RED BARN MACHINE	
TITLE M/R BLADE RETENSION BOLT PULLER	
DWG NO. RBW6205G08451-3G	REV 2B
MAT'L 6061	DRAWN BY: SMITH
UNLESS OTHERWISE SPECIFIED DIMENSIONS ARE IN INCHES	APPROVED <i>D Weil</i>
.XXX ± .005 .XX ± .01 .X ± .1	HEAT TREAT FINISH CLEAR ANODIZE
FRACTIONS ± 1/32 ANGLES ± 5°	SPEC MIL-A-8625F, TYPE II, CLASS I
1. BREAK ALL SHARP EDGES .015 x 45° OR .015R	USED ON MODEL
2. DIMENSIONAL LIMITS APPLY AFTER PLATING	AGUSTA AW139
SCALE 1:2	DATE 10/17/2013
SHEET 1 OF 1

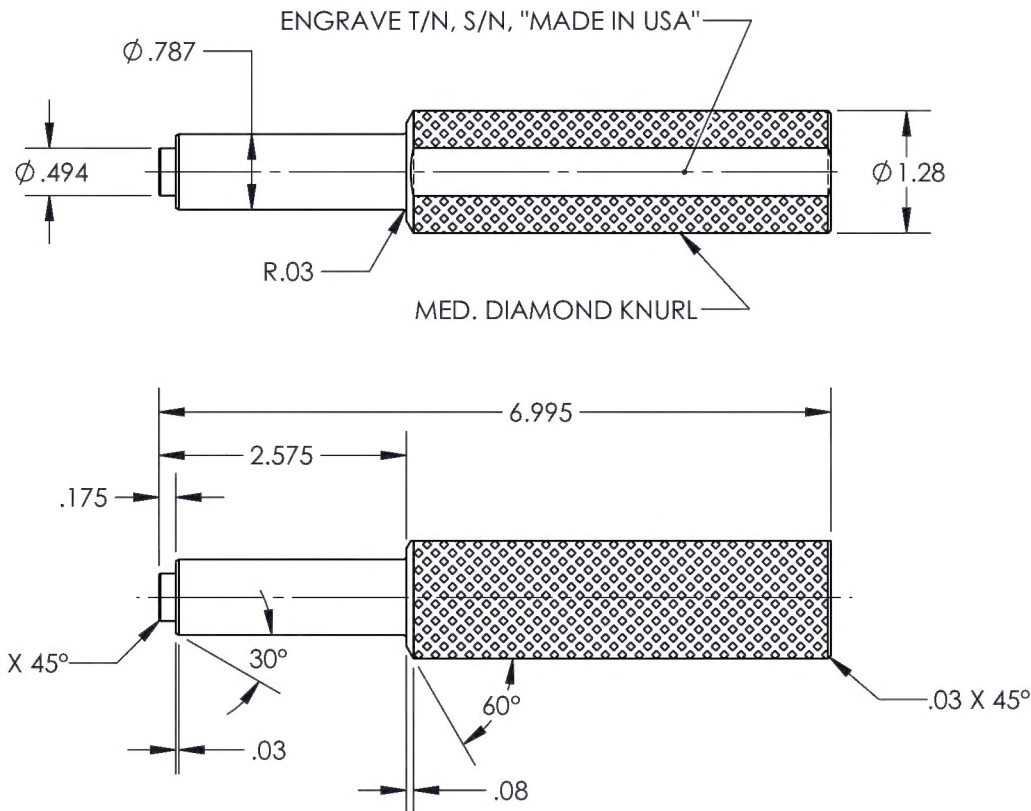
REVISIONS				
REV	DESCRIPTION	DATE	INITIAL	APPROVED
A	ADDED .455 REF. DIMENSION.	9/24/2009	WP	GE
1	CH'D HANDLE DIA., FROM ϕ 1.20 TO ϕ 1.28. REF. DIM. WAS .455 IS NOW .767.	9/28/2009	WP	GE
2	CH'D OD. WAS ϕ 1.28 IS ϕ 1.276, MILLED FLAT WAS .51 IS .587 REF., AND .767 REF. TO .50 REF. CH'D .032x60° TO .03 @ 30°, AND .08x60° TO .08@60°. ALSO ADDED VISIBLE KNURLING.	10/3/2009	WP	RW
2A	CH'D WAS CLEAR HARD ANODIZING IS CLEAR ANODIZING AND ADDED KNURL NOTE.	10/27/2010	WP	GE
2B	SEPERATED TOOLS FROM KIT RBW6205G00331-3G. CH'D DIM. LOCATION WAS REF. .587 IS 1.23. ADDED AW139 TO USED ON MODEL.	10/17/2013	CFS	RW
